Annual Monitoring Report

Cochran Stream and Wetland Restoration Site

RE: Cochran Branch Stream and Wetland Restoration Site: MY3 Monitoring Report
(NCDMS ID 95720)

Listed below are comments provided by DMS on January 10, 2018 regarding the Cochran Branch Stream and Wetland Restoration Site: Year 3 Monitoring Report and RES' responses.

Figure 2
Cochran Branch Stream Restoration Project
MY3 2017
Current Conditions
Plan View

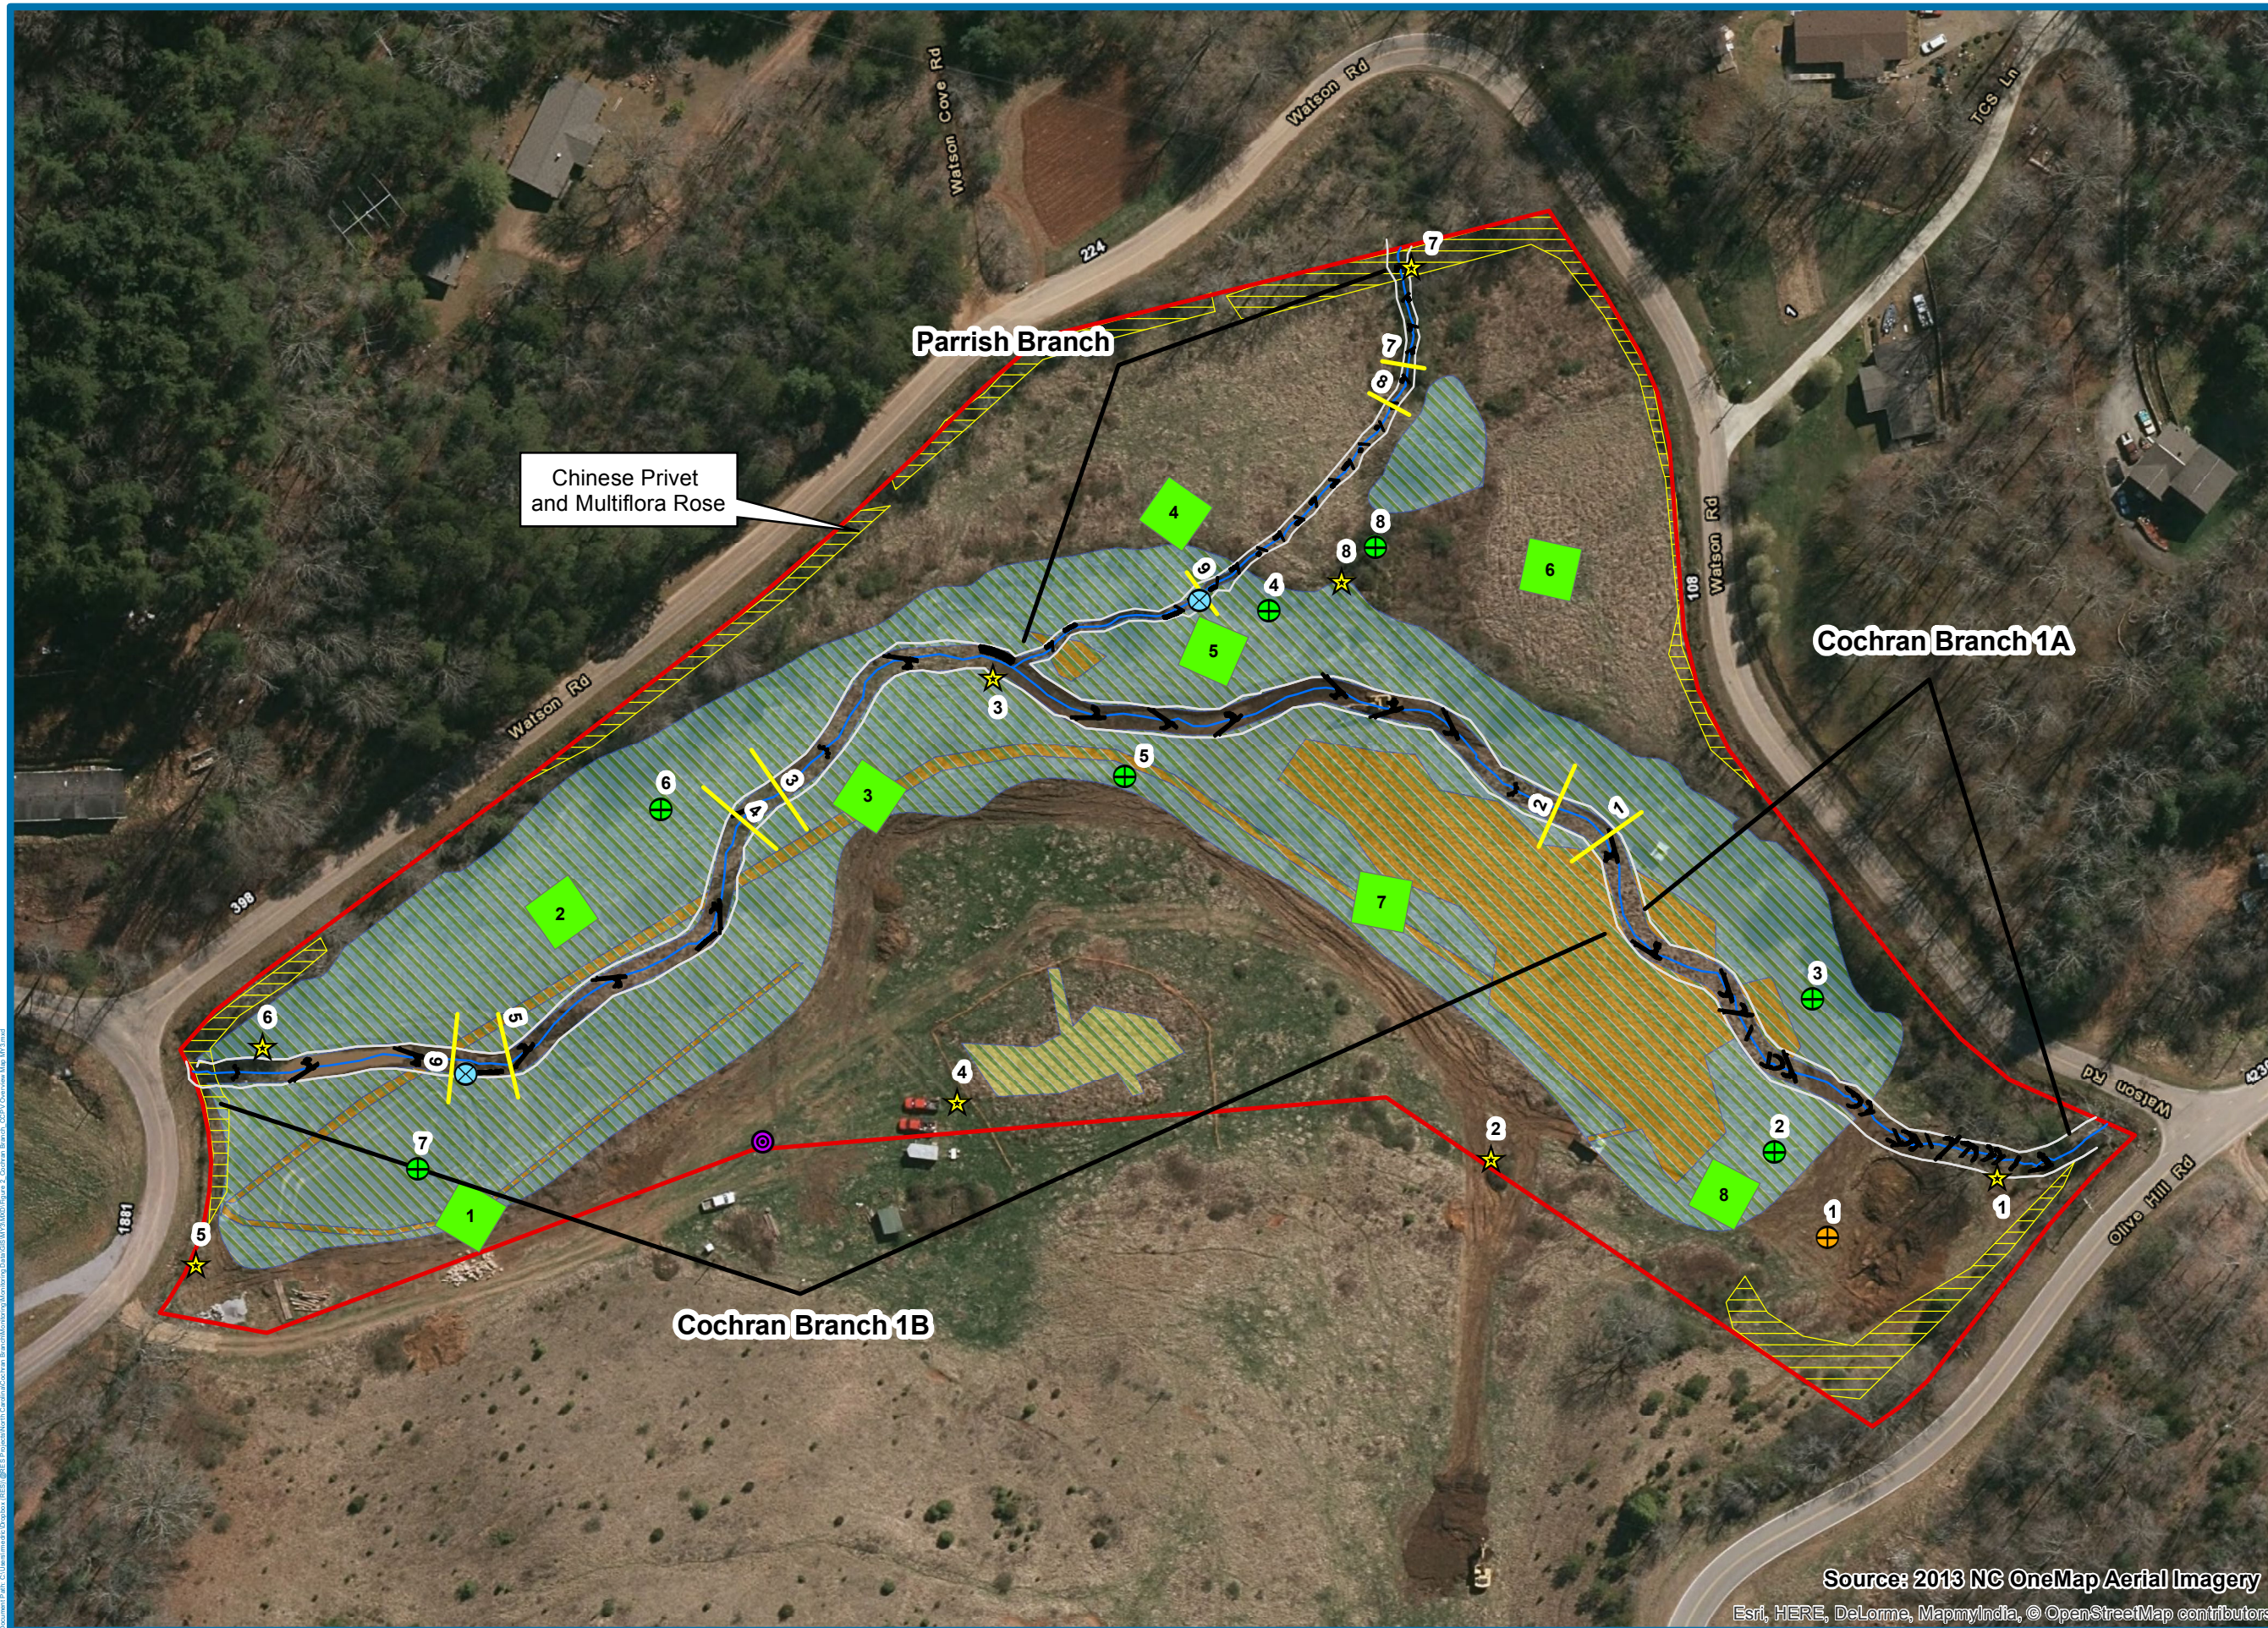
Section 1.4.1 - Vegetation: Invasive species were noted in the report verbiage and the CCPV mapping. Please note if any invasive treatment was conducted in MY3 (2017). In the report verbiage, please indicate if an invasive treatment is planned for the site in MY4 (2018).

No invasive treatment was conducted in MY3. The invasives are limited to the edge of the easement boundary and will be treated in MY4. This has been added to the report.
